REMARKS/ARGUMENTS

The Office Action mailed July 2, 2003, has been received and reviewed. Claims 1 through 33 are currently pending in the application. Claims 1 through 33 stand rejected. Applicants have cancelled claims 3-4, 11, 13-15, 17 and 27-32, amended claims 1, 2, 5-10, 12, 16, 18-26 and 33, and respectfully request reconsideration of the application as amended herein.

FIG. 1

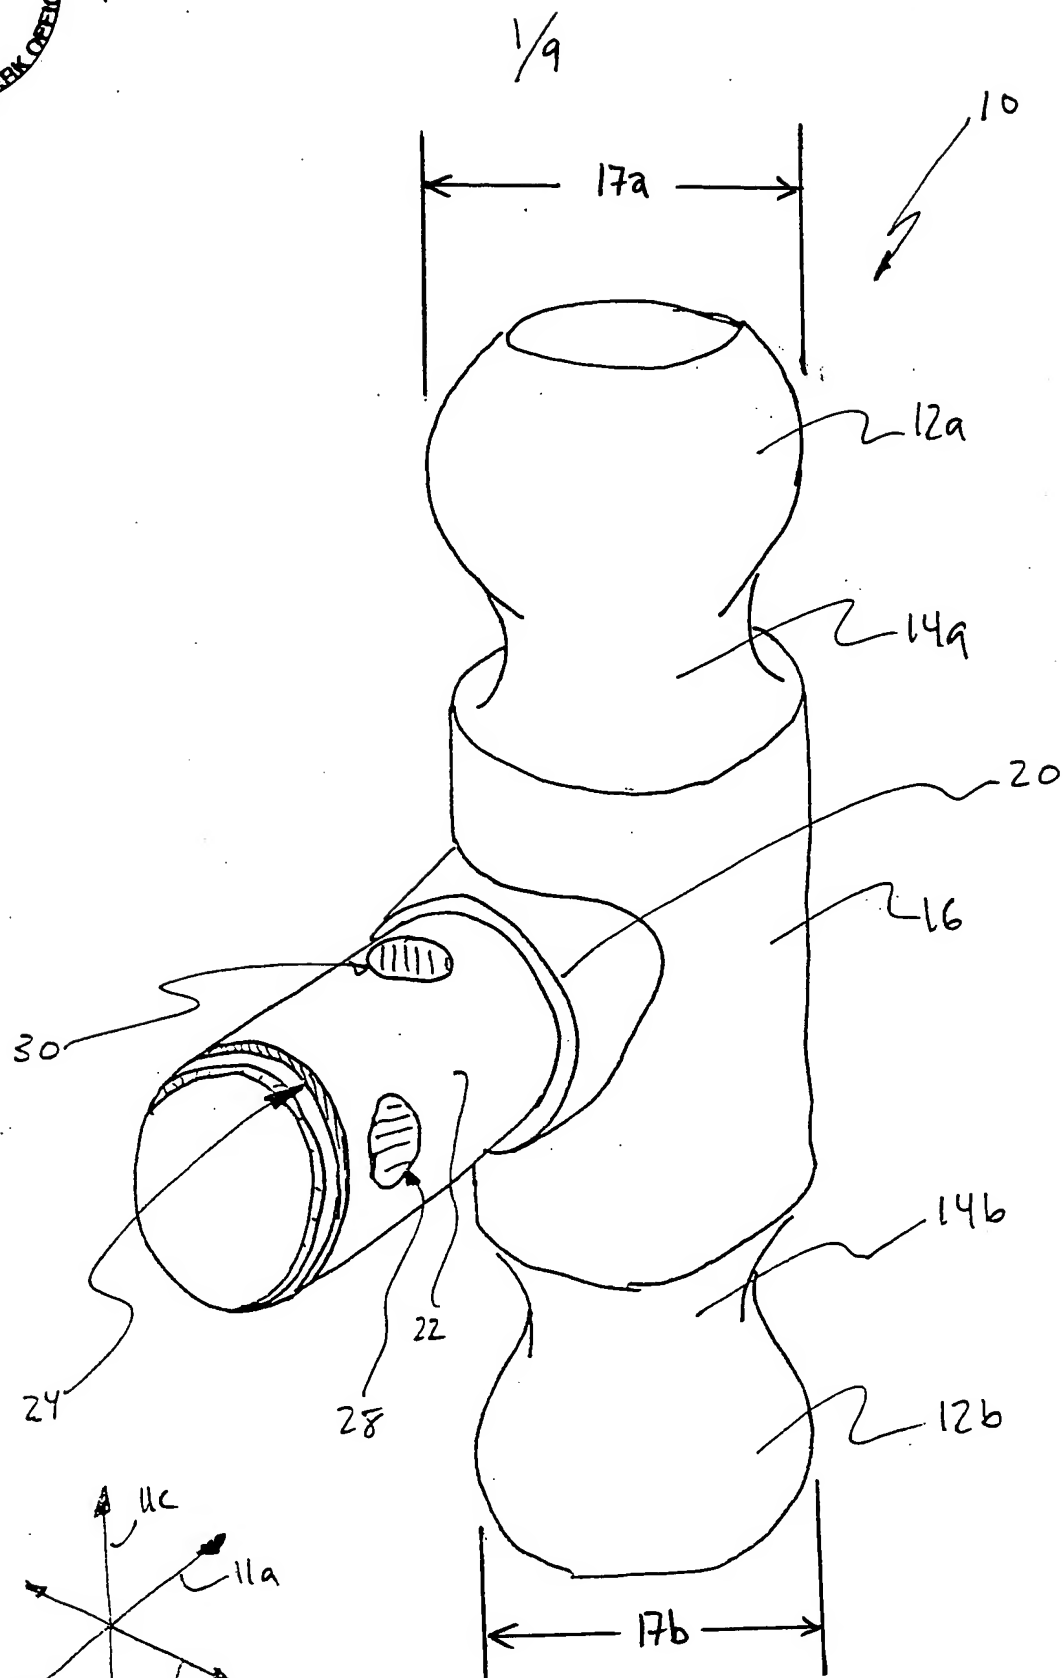
The drawings have been objected to as failing to comply with 37 CFR 1.84(p)(4) and (5), and corrected drawings are required in reply to the Office Action.

Applicants have revised FIG. 1 to show reference numerals 17a and 17b with associated lead lines. With respect to the remaining objections to the drawings, Applicants have amended the specification to make the specification consistent with the drawings and remove and perceived ambiguity. Applicants submit that such revisions address the Examiner's objections and respectfully request reconsideration of the drawings.
